CARVER CORPORATION
SERVICE BULLETIN

Service Bulletin # M-2020-3

Model M-2020

NOTES ON NOISE FILTER CHOKE INSTALLATION

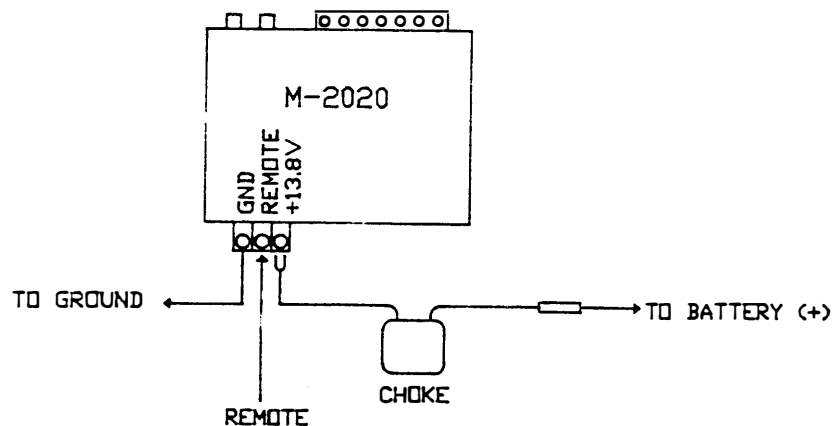
THE OUTBOARD FILTER CHOKE IS PROVIDED TO ELIMINATE ALTERNATOR-INDUCED NOISE IN THE M-2020 AMPLIFIER. IT SHOULD NORMALLY BE INSTALLED IN SERIES WITH THE GROUND POWER CONNECTION, BUT SOME INSTALLATIONS MAY BE MORE EFFECTIVE IN SERIES WITH THE POWER (+) LEAD DEPENDING ON AGE AND MODEL OF CAR, TYPE OF INSTALLATION, WIRING SCHEME USED, ETC. THE CHOKE IS BI-DIRECTIONAL, I.E. IT DOESN'T HAVE A PREFERRED POSITIVE OR NEGATIVE LEAD. IT DOES NOT HAVE TO BE MOUNTED CLOSE TO THE AMPLIFIER. HOWEVER, THE ATTACHED SPADE LUG MAKES A CONVENIENT CONNECTION TO THE AMPLIFIER POWER TERMINAL BLOCK.

NORMAL CHOKE CONNECTION

ALTERNATE CHOKE CONNECTION

Procedure: Install Noise Filter Choke (P/N 601-00664-00) in series with the ground wire. See installation instructions.

Service Bulletin # M-2020-2

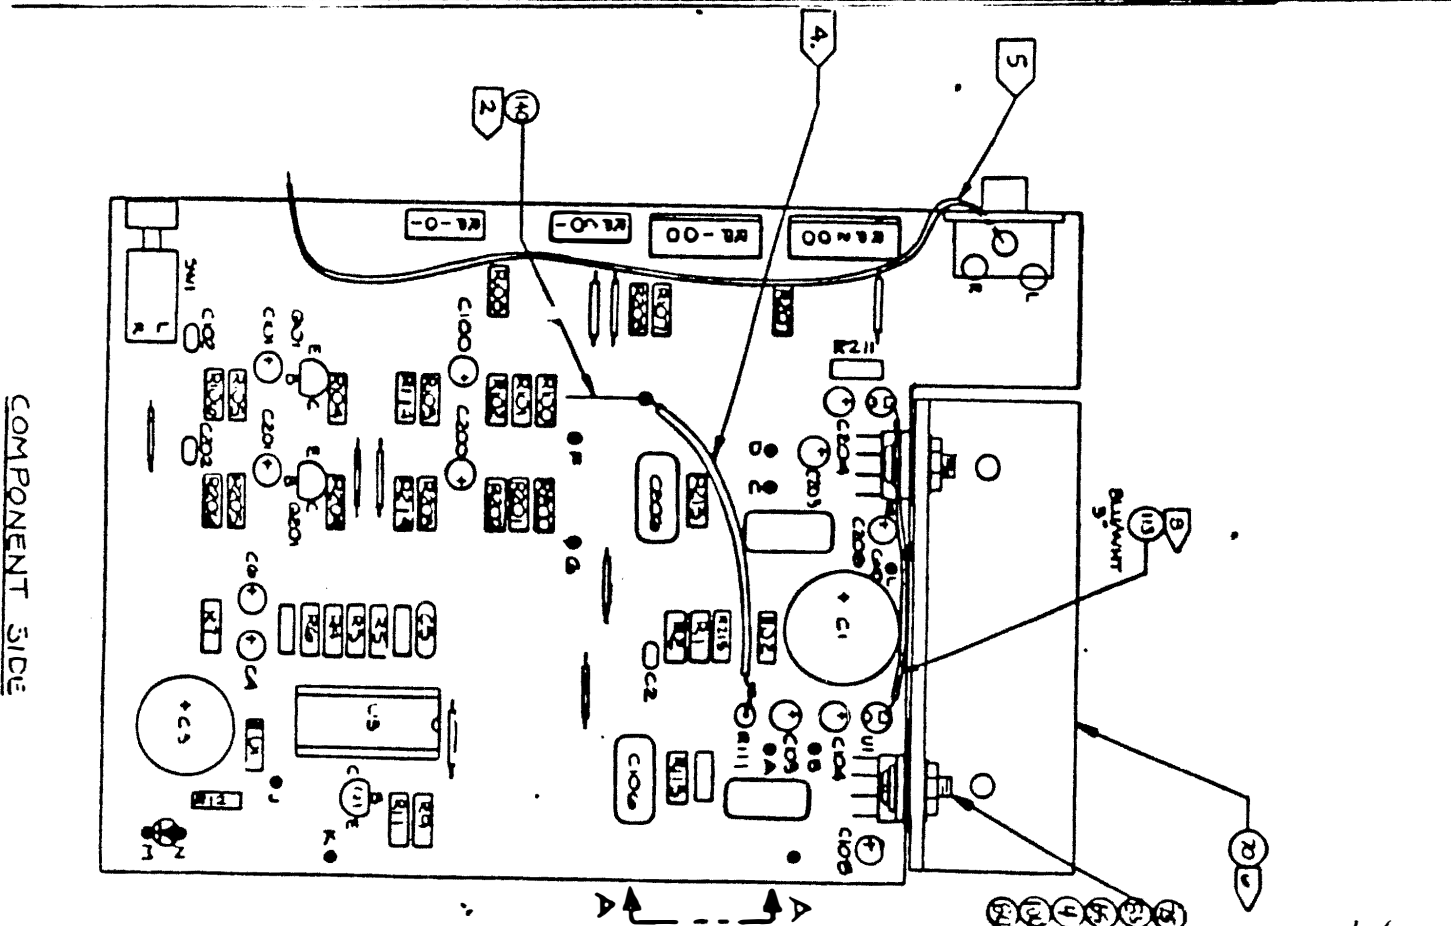
Reason: Turn off "pop" on the output.
THIS MUST BE DONE ON ALL UNITS.

Procedure: Remove jumper wire (Remove the jumper wire at location R215)
Add a 47 ohm resistor 1/4 watt where the jumper wire was removed.
Cut trace on the foil side of the board. (see page 2)
Add a three inch jumper wire to the component side of the board that goes from pin 2 of U1 to pin 2 of U2. (see below at note 113)
Remove C105 and C205 22uf 16v caps.
Add a 47uf 16v cap to the foil side of the board with the "-" side of the cap to ground and the "+" side to the other end of the 47 ohm resistor. Add sleeving to the leads of the cap. (see page 2)

Delete: Qty-1 401-30002-00 jumper
Qty-2 205-00013-00 22uf 16v

Add: Qty-1 251-00038-00 47 ohm 1/4watt
Qty-1 205-00013-00 47uf 16v
Qty-1 401-10583-00 3" 22 gauge
Qty-2 402-00012-00 .3" sleeving
